# MEMORANDUM

**FILE NO.:** INQ2012 0006

**PROPOSAL:** Inquiry into whether a homeowner's association is needed to oversee maintenance for shared driveways for a proposed subdivision.

**A PLAN OF CONCEPT LAYOUT OF GRANT CREEK HOMES PHASE I & II JUNEAU, ALASKA**

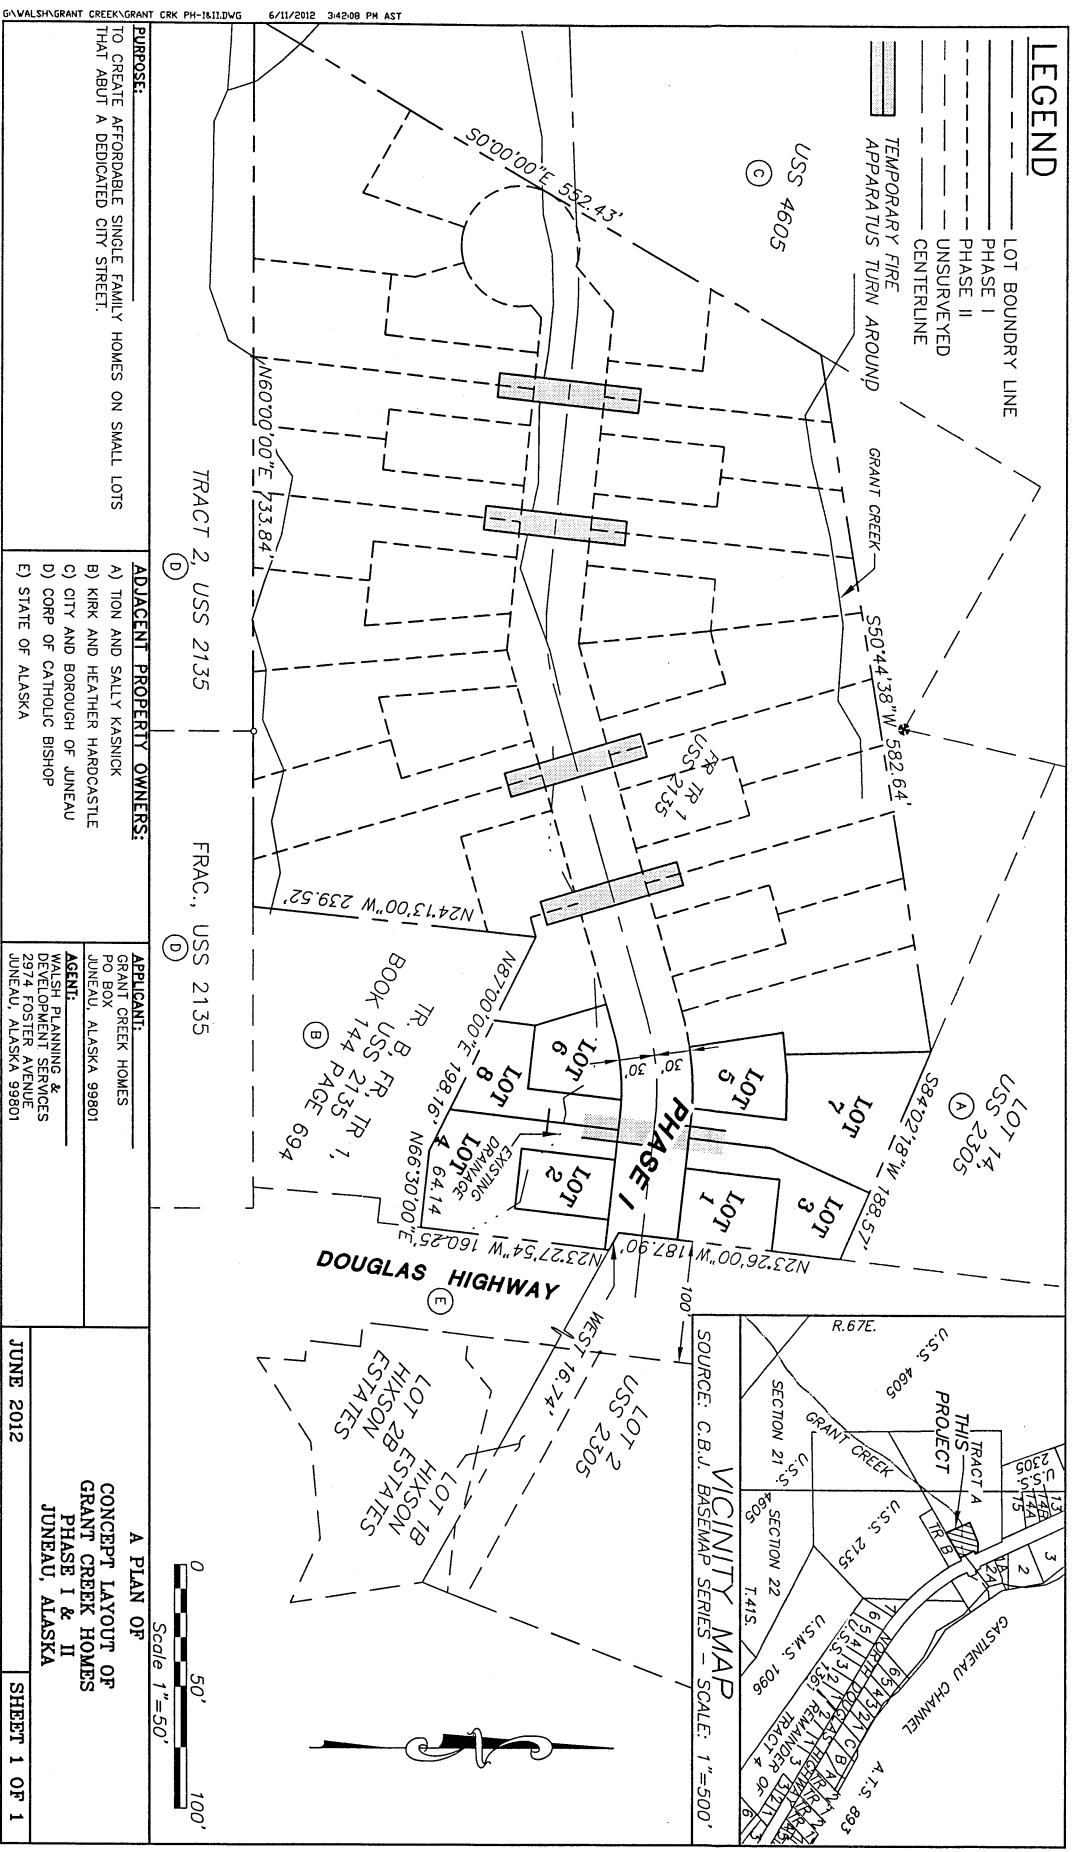
This is a proposed subdivision located on North Douglas Highway, on 8.78 acres. The subdivision is proposed to be built and platted in stages. The lots will conform to D-18 zoning requirements and will be configured so that each of the four lots shares a common driveway, as shown on the sketch plat on Page 4 of Attachment B.

- FIRE: (Sven Pearson, Deputy Fire Marshall) Our main concern would be clear winter time access and who will be responsible for maintaining the common vehicle roadways in the future. Relying on four individual home owners to agree on a solution for consistent maintenance may be a challenge. Although it may be easy to have an agreement at this point that addresses these concerns, we need to look at what the reality is for consistent wintertime maintenance. All roadways would need to be completely cleared for fire apparatus access. We are seriously concerned of who will take on the responsibility of keeping all access roads free of snow during wintertime. In addition, vehicle parking along the access road would also limit fire apparatus access.

This concern needs to be addressed not just to satisfy the time period while the developer completes the project, but be ongoing for the life of the development. A possible solution may be the formation of a home owner association to take on this responsibility.

- POLICE: (Greg Browning, JPD) Nothing from the Police Department.
- STREETS: (Ed Foster, Streets Division, Public Works) Require the street to be built to Standard 102A, paved with curb and gutter. Separating the street and sidewalk with drainage is going to place the sole responsibility of clearing snow from sidewalk on the adjacent property owner. With the sidewalk on back side of curb we can help keep clear of snow when plowing. Considering the slope, any open ditch drainage should require rock check dams built to Standard 312. NOTHING allowed to be constructed in the 60' ROW, with the exception of sidewalk, drainage and utilities. NO STAIRS. Stairs to private residence to remain on the private property.

recognize it as a street, until it is complete with cul-de-sac built to Standard 107, or a 120' hammer head at the end. It would be very difficult to plow snow from this street without adequate turn around. Backing into driveways to turn around is not an acceptable option. It opens the CBJ up to damage claims and often CBJ is plowing streets before residents have cleared their driveways. Turning around in a driveway before it has been plowed will make it very difficult for the property owner to clear the snow, thus creating another claim that CBJ has to make good on. I recommend the developer be responsible for snow removal of the street and driveways until such time a complete street has been constructed with compliant cul-de-sac.

Would want to see the entire subdivision drainage plan before permitting. Also this street will require a "Stop" sign at N. Douglas Hwy. installed in accordance with MUTCD standards.

- **ENGINEERING:** (Ron King, General Engineering) Interesting concept; definitely each common driveway cluster will require an easement to be delineated on the plat with a recorded joint use agreement. Conceptually I think the plan would work but the developer must agree to the improvements required by Public Works & CCFR such as:  
Typical road section needs to be addressed; application shows offset sidewalk with open drainage.

Drainage report for the final subdivision shall be submitted verifying down stream culverts, crossings and all drainage below Douglas Hwy will carry the additional drainage. Fire apparatus access will require NO PARKING FIRE LANE signs.

Require snow storage area beyond the end of pavement utilizing BMPs.

Roadway must extend beyond the 8 lots to a point that a full size hammerhead or cul-de-sac may be built. I would suggest that the hammerhead be placed at the driveway location for the next set of lots.

If no dedicated turn around the homeowners will have to maintain the road & driveways therefore a homeowner's agreement is required.

In each set of four homes, the rear two lots appear to be small panhandle lots that have at least 30 feet of frontage on the proposed new road. This lot design could be approved by the Director under the section of Title 49 stated above; however, staff has concerns about the continued maintenance of the shared driveway and access to these rear two lots.

The developer is proposing that each set of four homeowners agree upon a method to ensure continued maintenance of the shared common driveway. However, staff has concerns about this approach because safety access is of paramount importance during an emergency. In the event an agreement is not able to be reached amongst the four homeowners or if it falls apart, access to the rear two homes becomes jeopardized. For these reasons, staff supports an owners' association to oversee maintenance of all the shared common driveways in the subdivision to ensure continued access.

If they build the road to CBJ Standards with a hammerhead beyond this phase of the subdivision (next proposed DW) then CBJ would maintain the main road, therefore individual homeowners would be fine.
